# HISTORIC AND DESIGN REVIEW COMMISSION

July 17, 2024

**HDRC CASE NO:** 2024-236  
**ADDRESS:** 849 E COMMERCE ST (Suite 171)  
**LEGAL DESCRIPTION:** NCB 151 LOT 3, A1,A2,A3,A4,A5,A6,7,8,60,61, 62,63,65,A66 & 64 EXC SW 32 FT (2.533 AC) & NCB 1010 BLK 2 LOT 26 (.99 AC), 28 (1.44 AC), 31 (.71 AC) & PT OF LOT 30 (5.11 AC)  
**ZONING:** D, RIO-3  
**CITY COUNCIL DIST.:** 1  
**APPLICANT:** Vickie Ashmead/US Permit LLC  
**OWNER:** NEW RIVERCENTER MALL II LP  
**TYPE OF WORK:** Store front modifications, patio furniture and signage  
**APPLICATION RECEIVED:** June 28, 2024  
**60-DAY REVIEW:** August 27, 2024  
**CASE MANAGER:** Edward Hall  
**REQUEST:**

The applicant is requesting a Certificate of Appropriateness for approval to:

SHEET TITLE:  
EXTERIOR  
ELEVATION -  
PROPOSED  
FACADE  
SHEET NO.  
A3.1

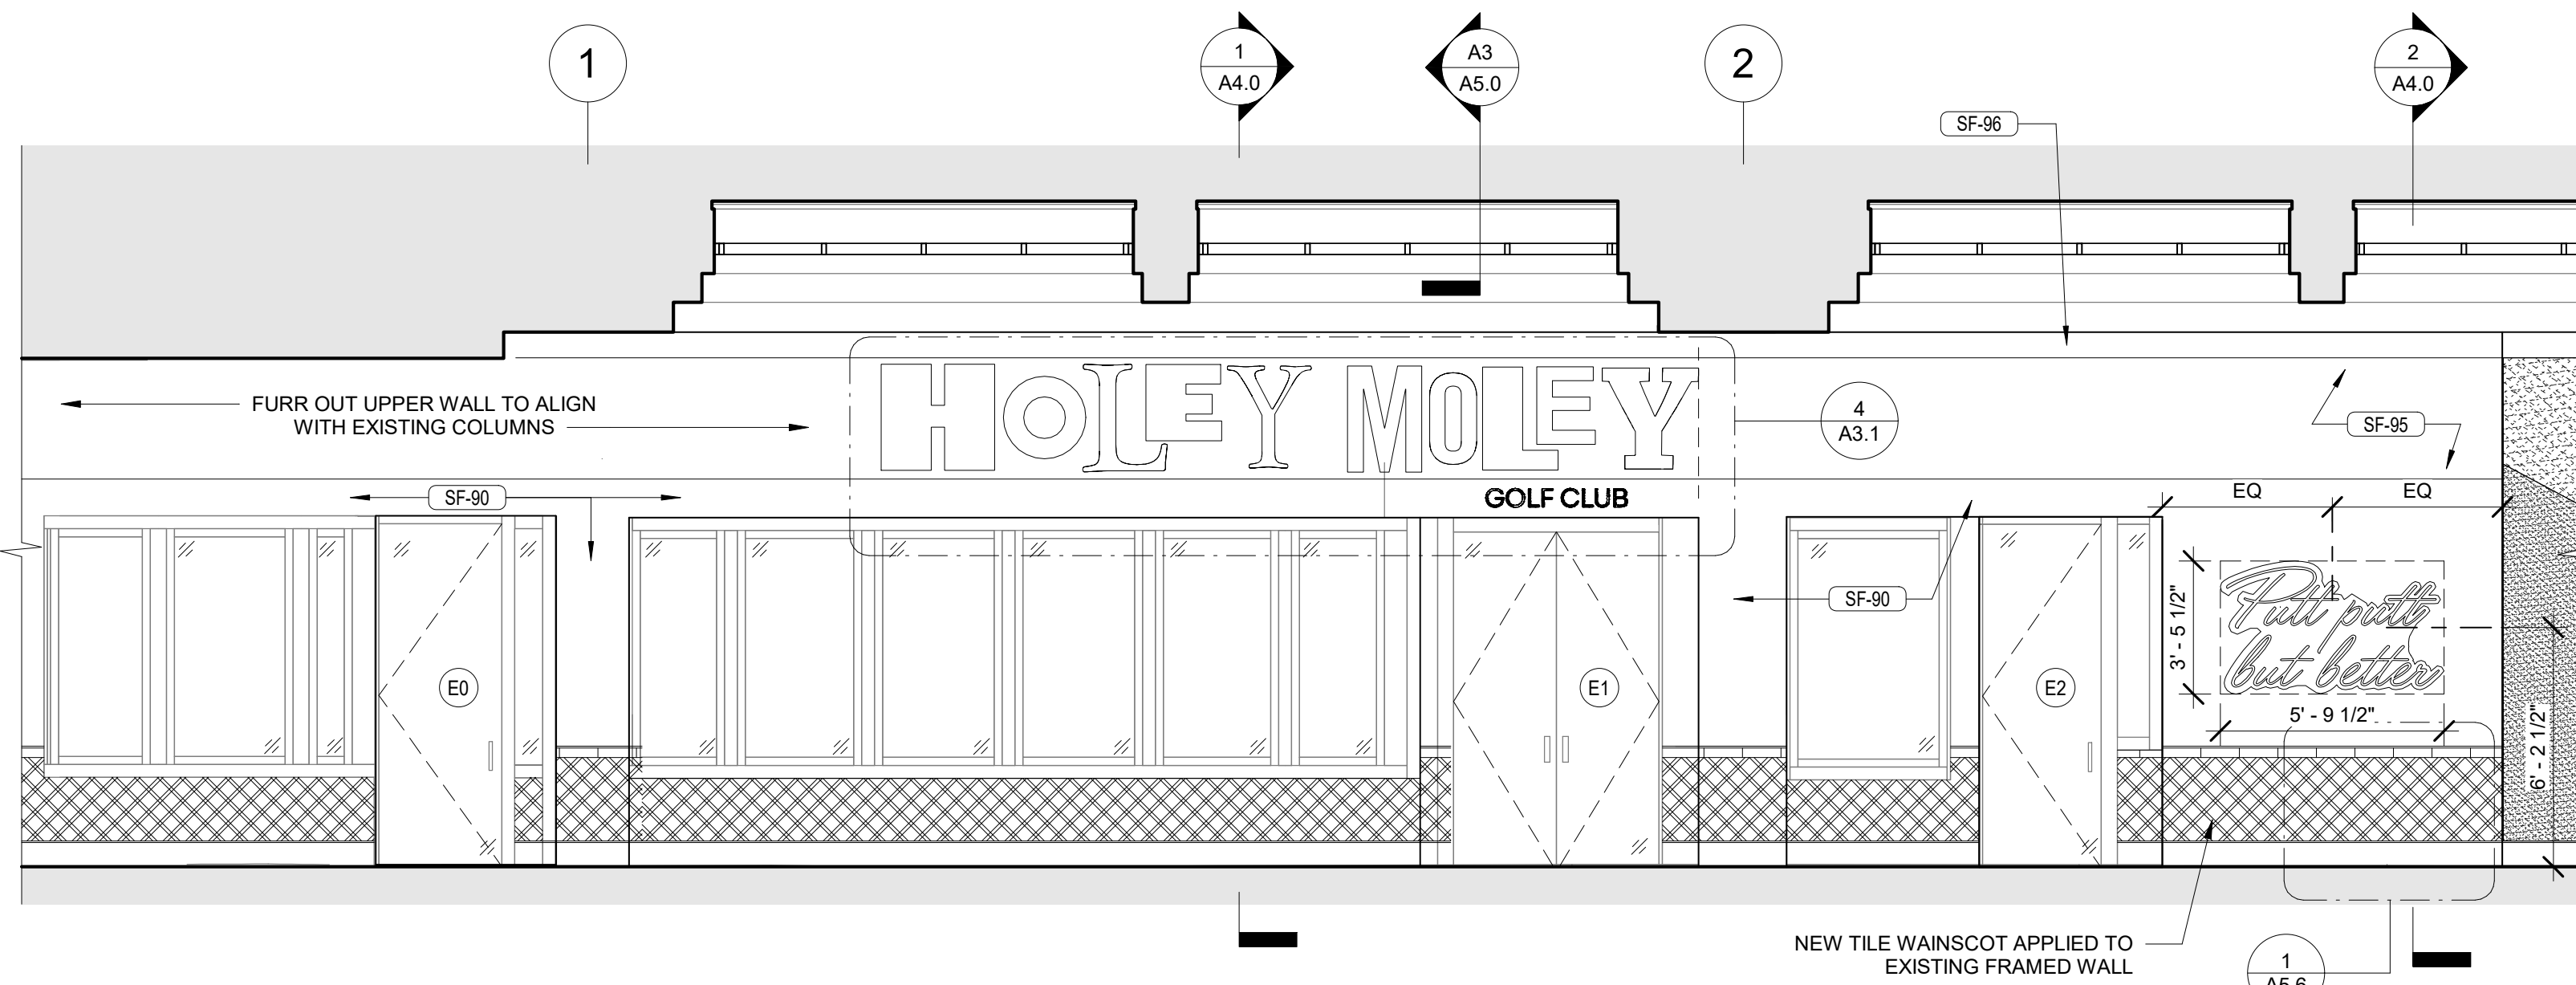
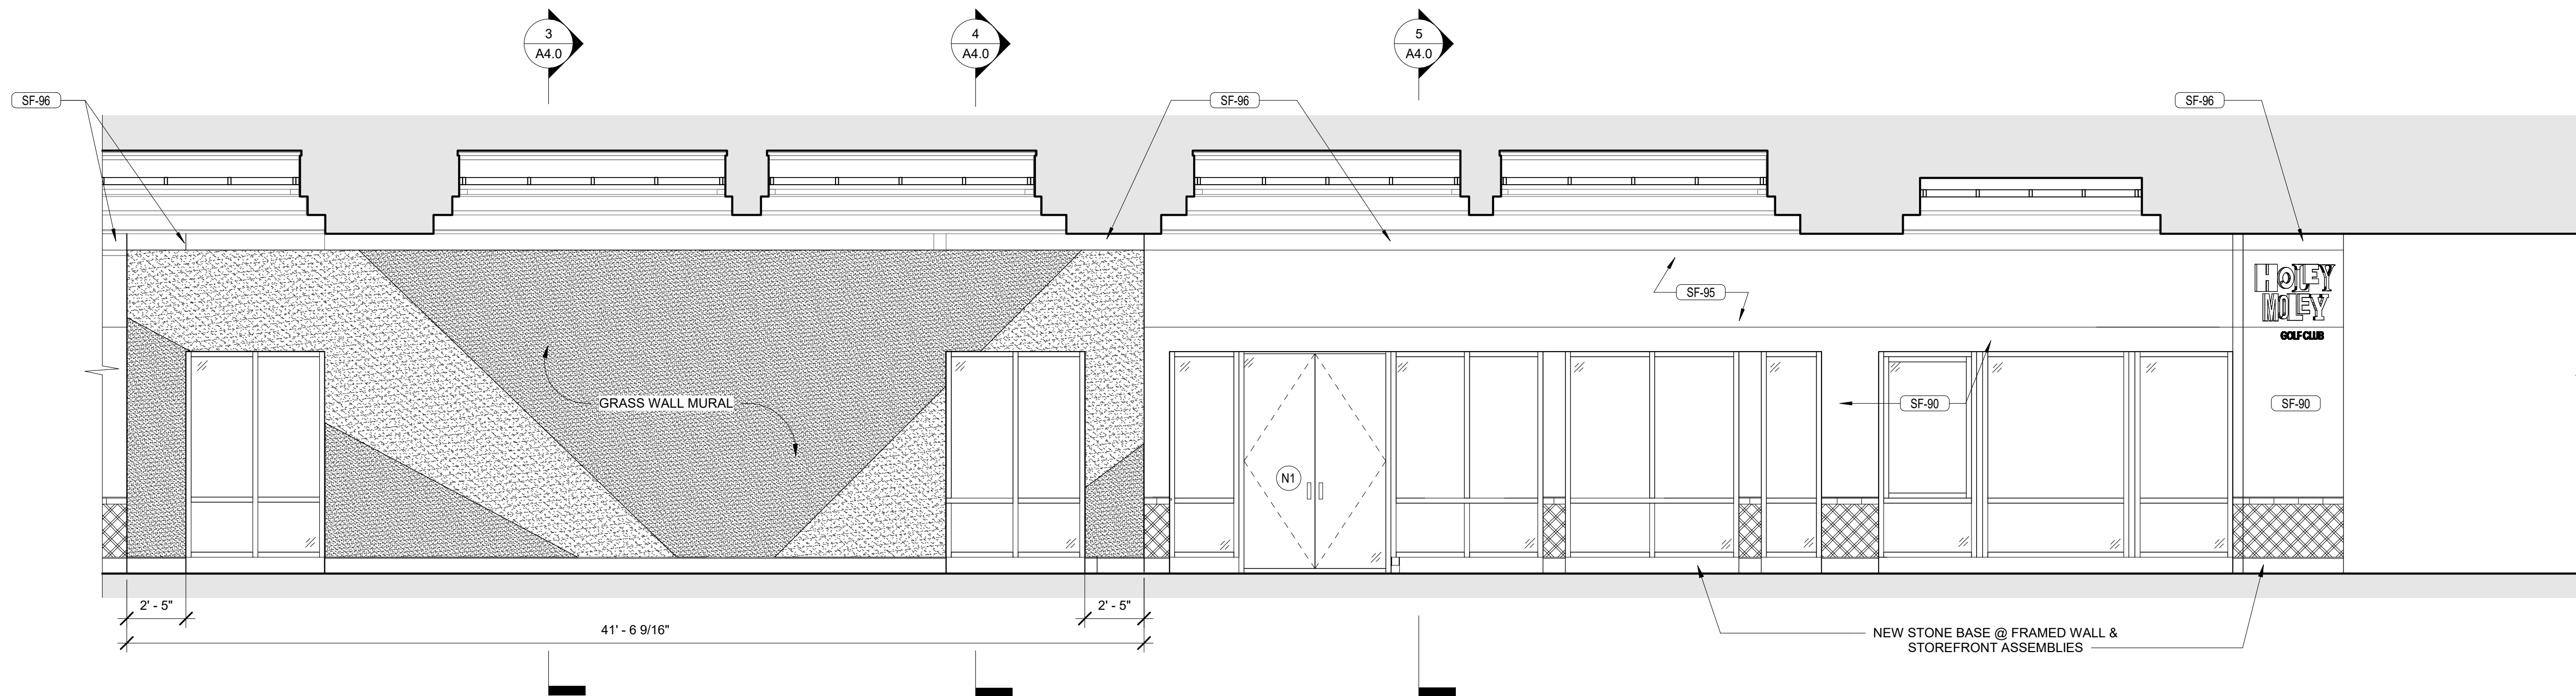
- b. STOREFRONT MODIFICATIONS – The applicant has proposed to perform modifications to the existing, lagoon facing façade within the colonnade by installing a new storefront system, installing new tile wainscoting beneath an existing storefront system, installing a faux grass wall mural, installing a new stone base beneath the proposed storefront system, and installing furr walls to align with existing columns. Generally, staff finds the proposed modifications to be appropriate; however, staff finds that the final design of the proposed grass wall mural should be submitted to staff for review and approval.
